J. T. Beckham, Jr.
Vice President - Nuclear
Hatch Project

HL-5146

Edwin I. Hatch Nuclear Plant - Unit 1
Inservice Inspection of
Reactor Pressure Vessel Welds

SCALE	DRAWN BY	SKETCH NUMBER
NOT TO SCALE	WS	ISI-SK-153

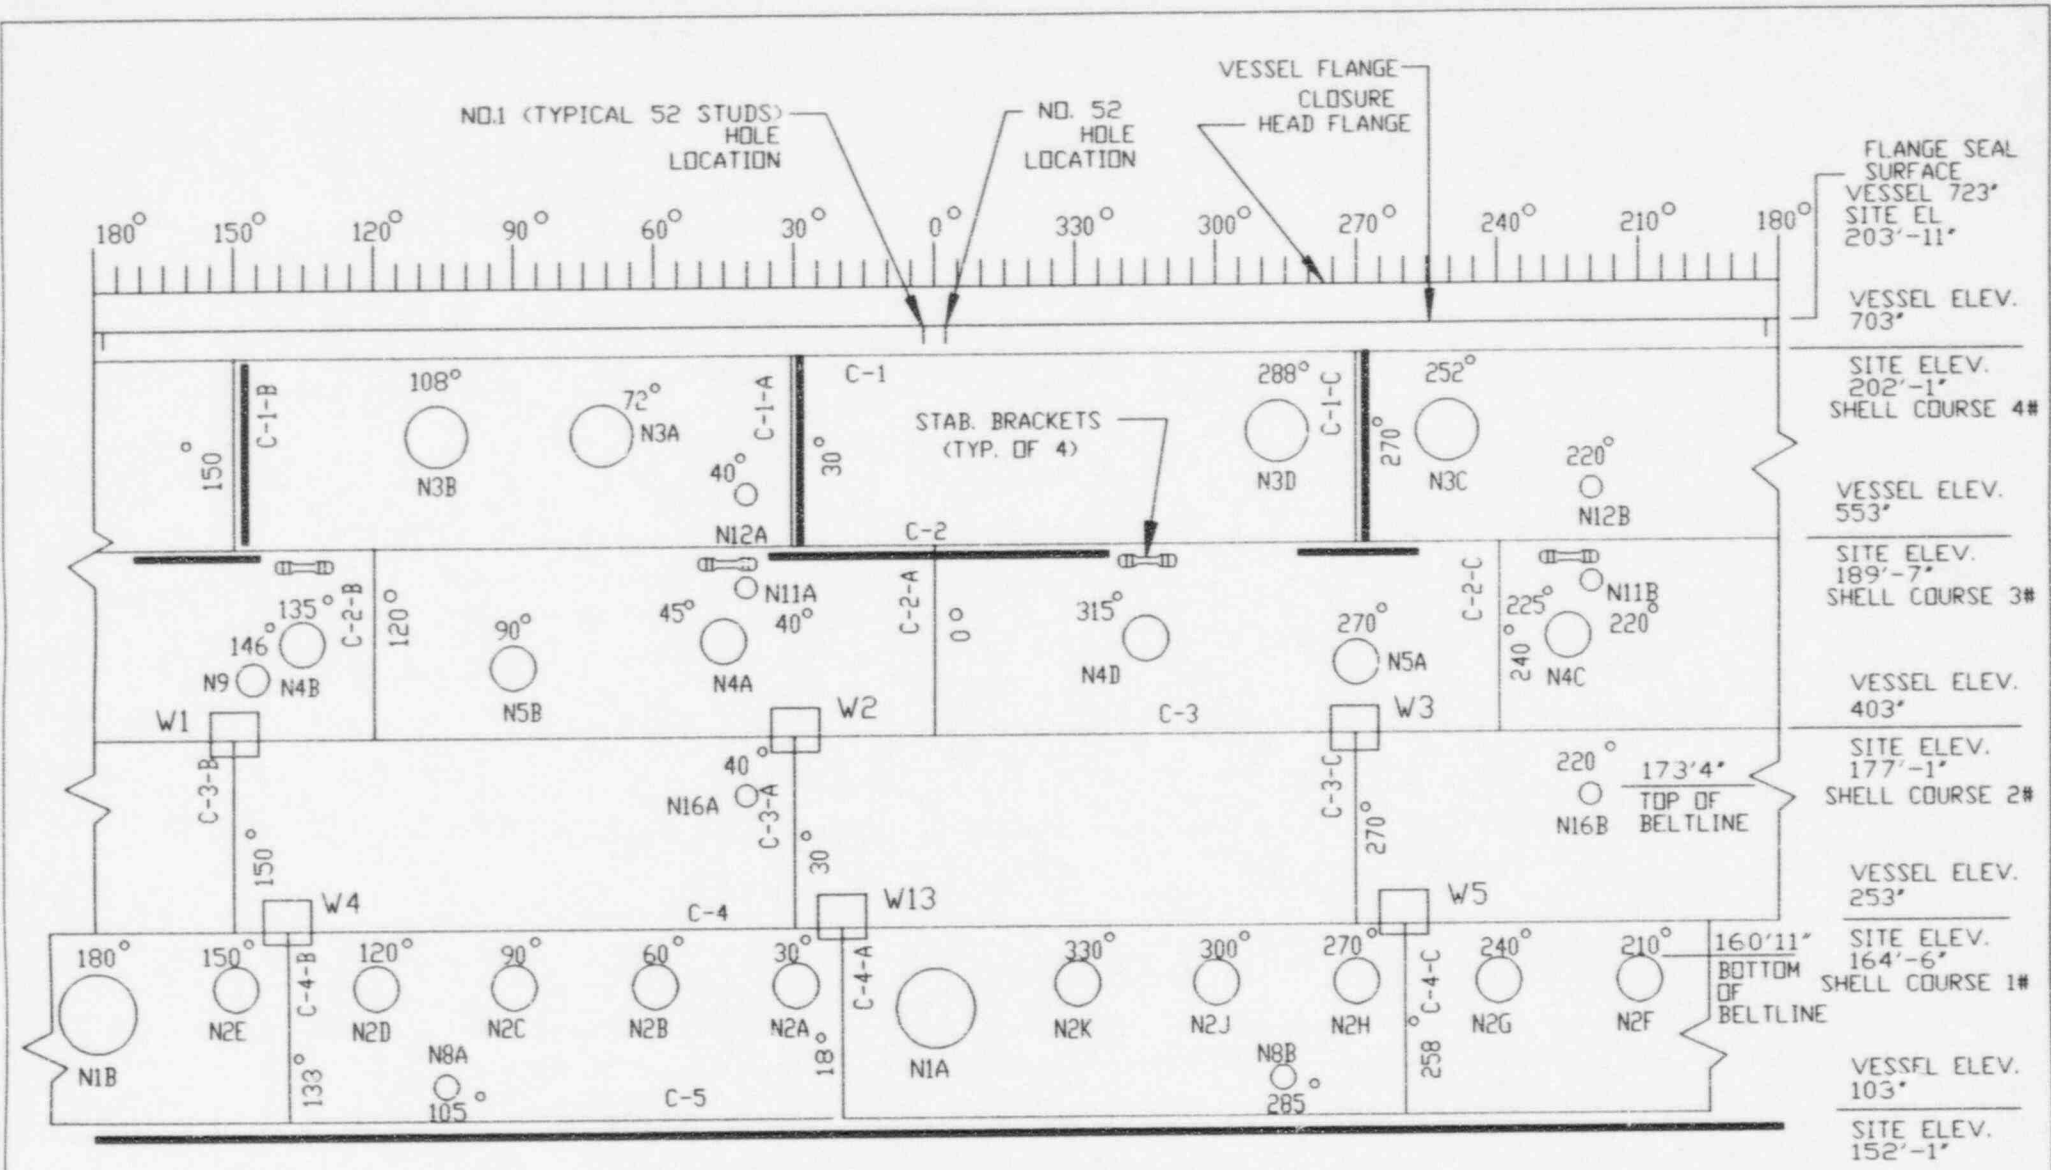
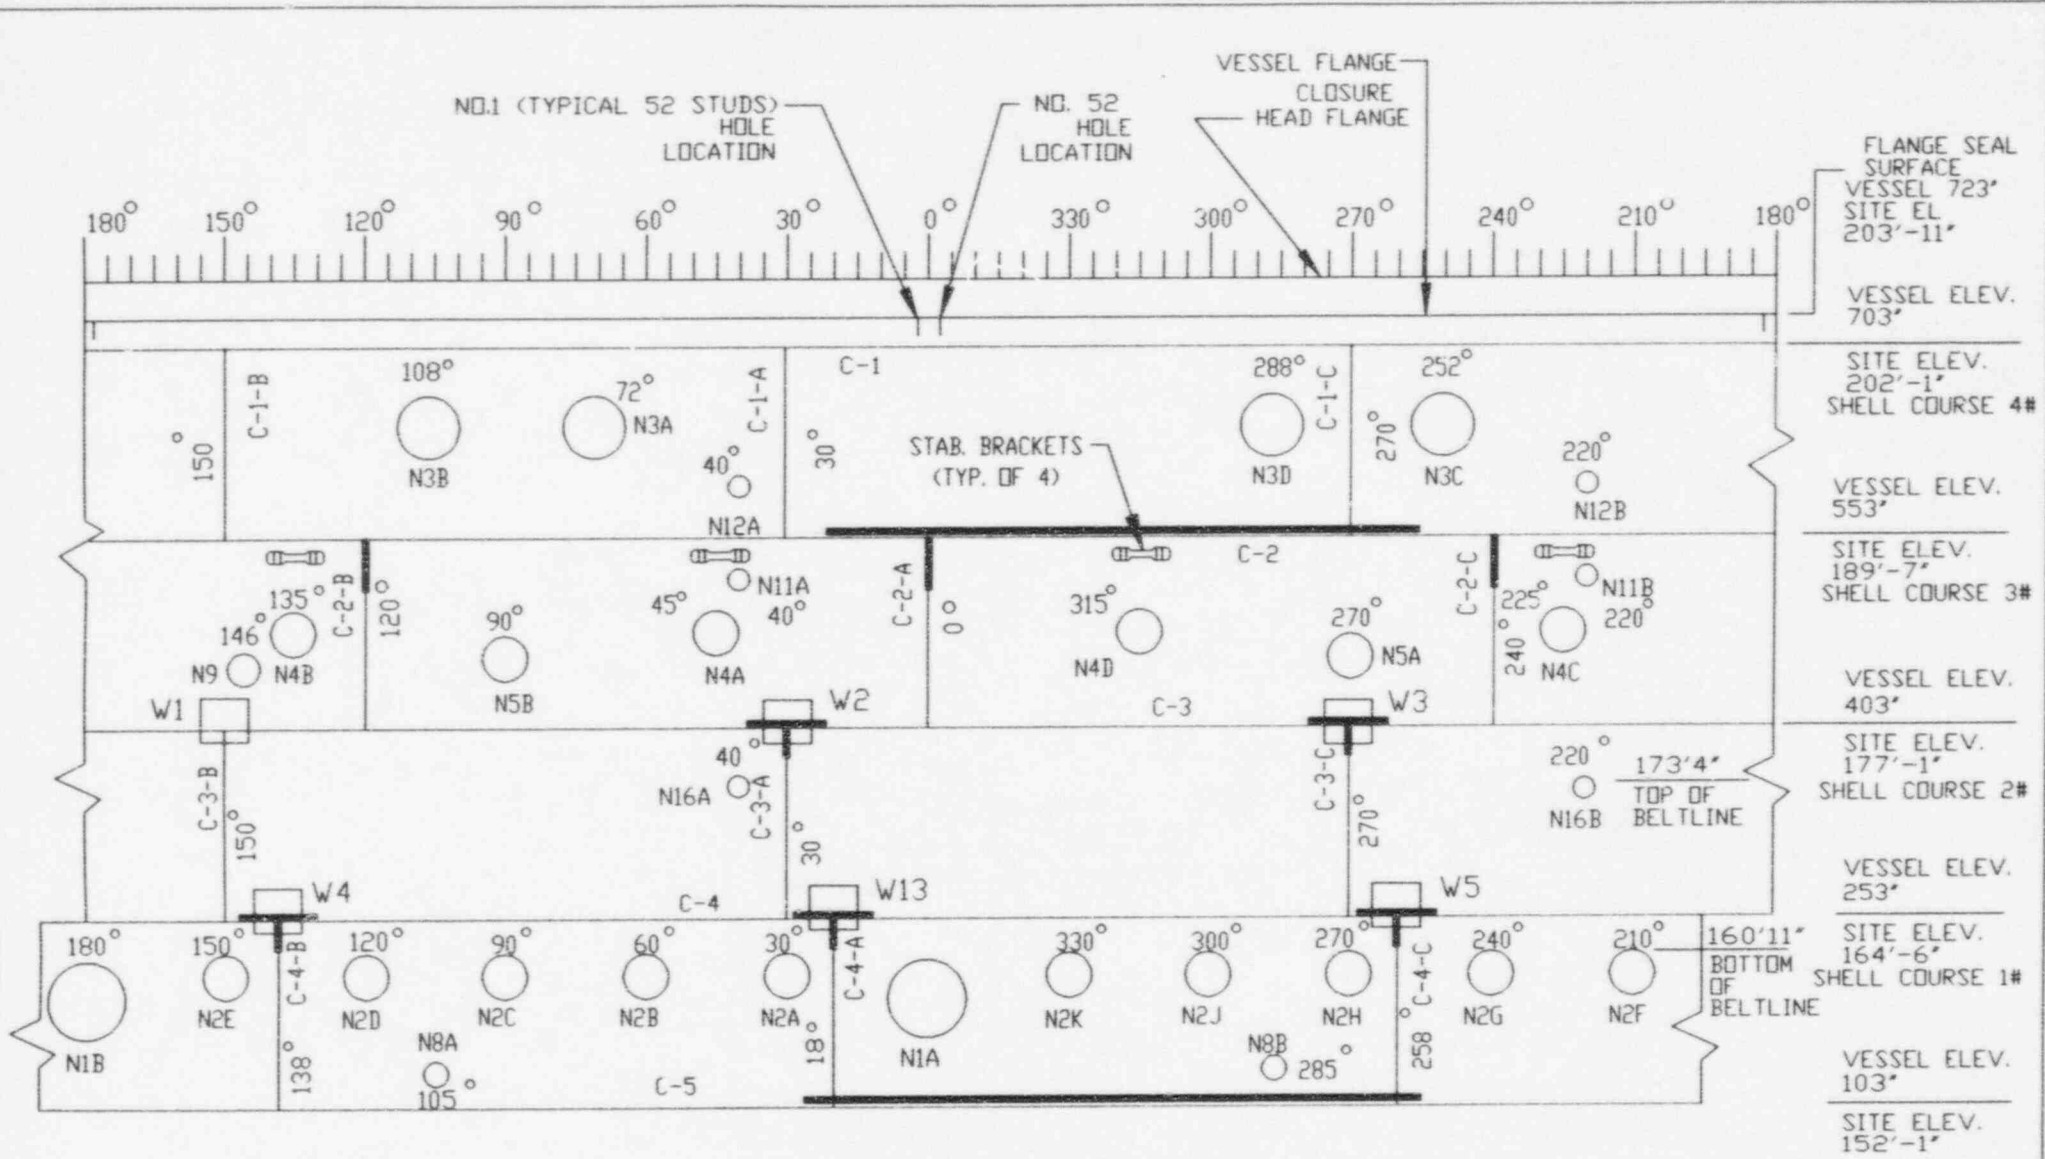
In recognition of as-low-as-reasonably-achievable (ALARA) principles, GPC's letter dated December 4, 1995, stated that the inspection scope was subject to revision relative to the extent to which any particular weld would be examined. The final specific scope would be determined based on ALARA. Consequently, during the Unit 1 Spring 1996 refueling outage, the inspection scope was redefined, as shown on Sketch ISI-SK-153. Based on health physics assessments of projected dose exposures for the original scope, GPC formulated an inspection scope that resolved the ALARA concerns and provided for appropriate inspections. GPC has evaluated the redefined scope and determined that the alternative examinations are acceptable. Specifically, the redefined scope results in an increase in the amount of weld examined, incorporates recent advances in technology for assessing RPV welds, and allows improved inspection techniques. Additional details are as follows:

1. The previous scope included welds which were accessible for manual examination only. The revised scope allows all examinations, circumferential and axial, to be performed using automated equipment, thereby producing more repeatable results by allowing for the electronic storage of signal data for later comparisons.
2. The amount of circumferential weld examined was equal to the equivalent length of one circumferential weld.

3. The revised scope provided a significant increase in amount of axial weld examined. This was accomplished by examining three entire axial welds as opposed to examining the equivalent length of one axial weld. This is an improvement in safety based on the BWR Vessel and Internals Project, BWR Reactor Pressure Vessel Shell Weld Inspection Recommendations (BWRVIP-05), EPRI TR-105697, dated September 1995. This analysis indicates that circumferential welds are less likely to encounter problems than axial welds.

4. Although a beltline weld was not examined, embrittlement is not an issue for Unit 1 since it has only 22 years of operation. The amount of fluence is equivalent to that of 2-3 years on a PWR. No adverse effects due to irradiation is anticipated at this point in the life of the plant.

5. The RPV contact dose rates at the three beltline inspection doors is 1.5 Rem/hr. to 1.7 Rem/hr. The configuration is such that only manual examinations could be performed and lead shielding could not be effectively used to reduce the radiation levels. In comparison, automated examinations were performed in the non-beltline area with a RPV contact dose rate of 35 mRem/hr. It is estimated that dose savings of approximately 15 Man Rem were achieved by making this change.

The change in scope for RPV shell welds inspection was based on the excessive radiation exposure to be received by performing the original examinations. The selection of these other welds has a positive impact on the safety and operation of the plant based on ALARA principles, permits the use of automated vs. manual examinations, and permits a larger sample of longitudinal welds to be examined to correspond to the findings of the BWRVIP report. Also, an RPV examination will be performed within the next forty-month period which will consist of the examination required by the NRC Augmented rule or the scope agreed to between the BWRVIP and the NRC.
